PROPOSED CHANGES TO SDI-12

SDI-12 is currently at Version 1.2, dated October 1996. Over the past two years, several proposed upgrades have been suggested to the SDI-12 Specification. The Technical Committee discussed these proposed upgrades at the 1998 annual meeting of the SDI-12 Support Group. That meeting was held last November, in Point Clear, Alabama, in conjunction with the annual American Water Resources Association's (AWRA) conference.

Spring 1999

Figure 1.

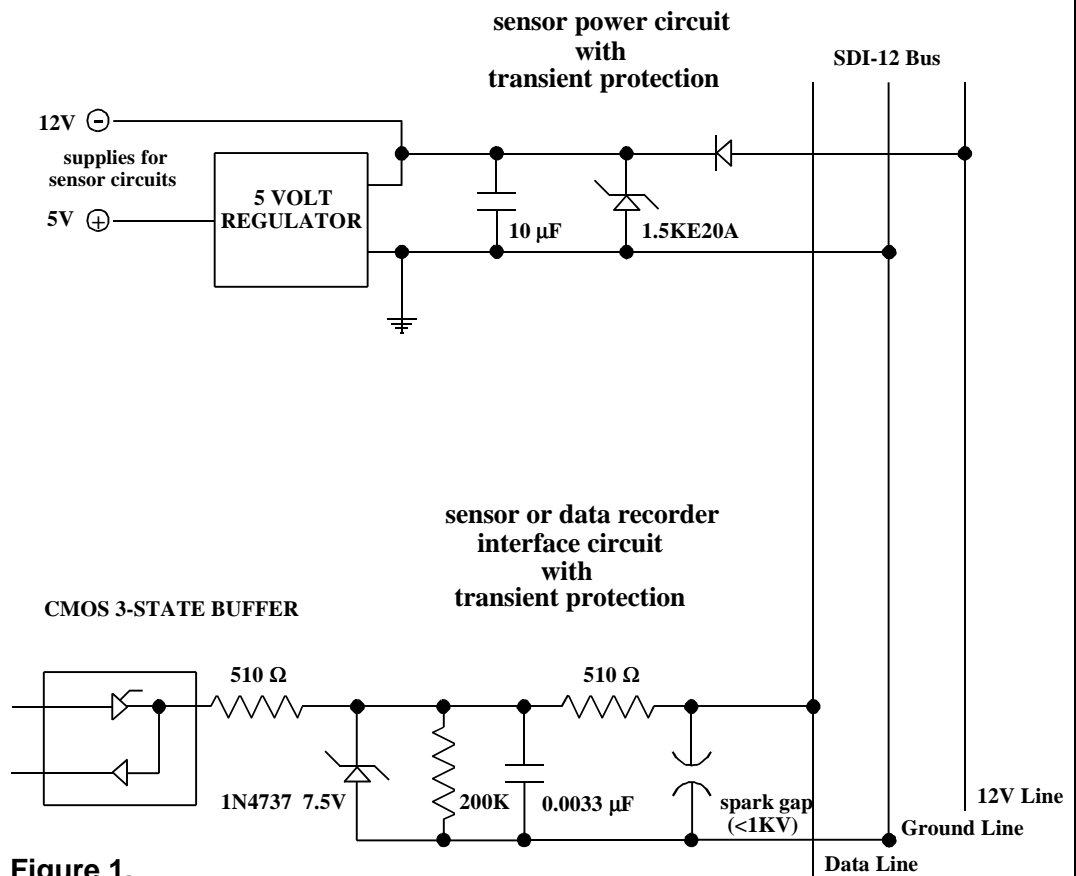
It was decided that the 1st sentence of the 2nd paragraph of section 3.3, of the SDI-12 Specification should be changed to:

For sensors connected to the 12volt line that exhibit an inductive load, a series diode is recommended. The diagram in appendix A of the SDI-12 Specification will be updated to show a series diode in the 12volt line connection. Figure 1 shows this circuit with the diode.

4) Do you agree to clarify the statement about inductive loads on the 12V line, by recommending the use of a series diode on the 12V line? (See Figure 1.)

Figure 2.

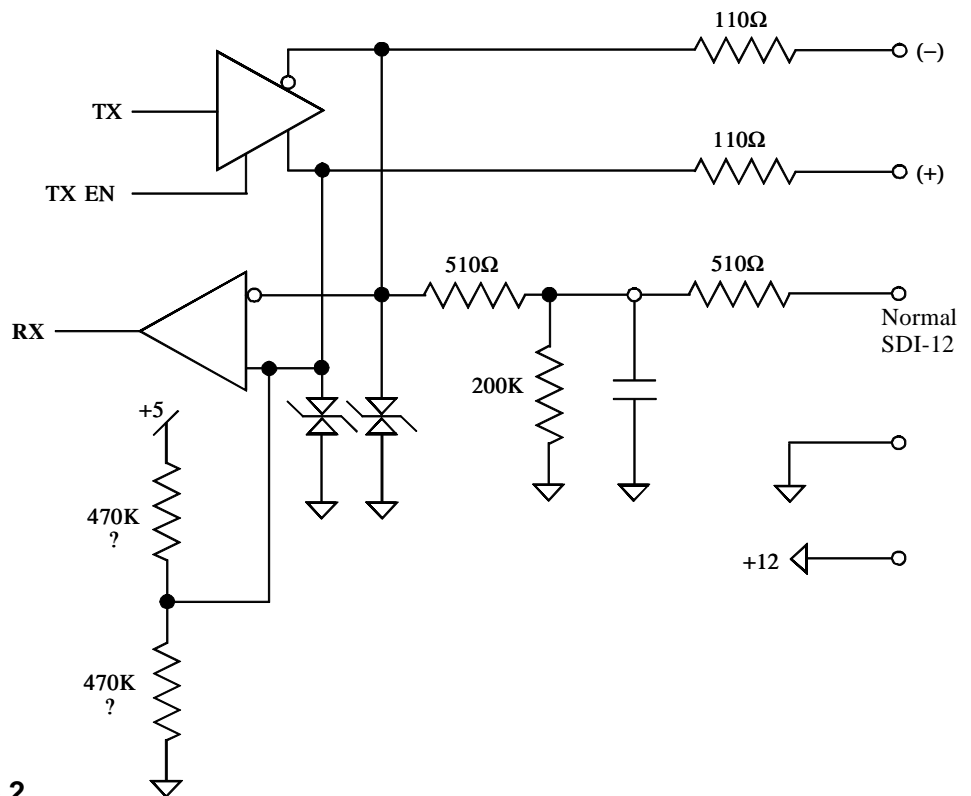
The question of possible support for differential SDI-12 to support longer data lines was reviewed by the Technical Committee. The question was whether differential support could be added in a manner that also supported conventional single ended SDI-12 in the same unit and would allow intermixing the two types in the same system. The following circuit was suggested as a solution. This circuit will be evaluated before being proposed as a specification amendment to the SDI-12 Specification.
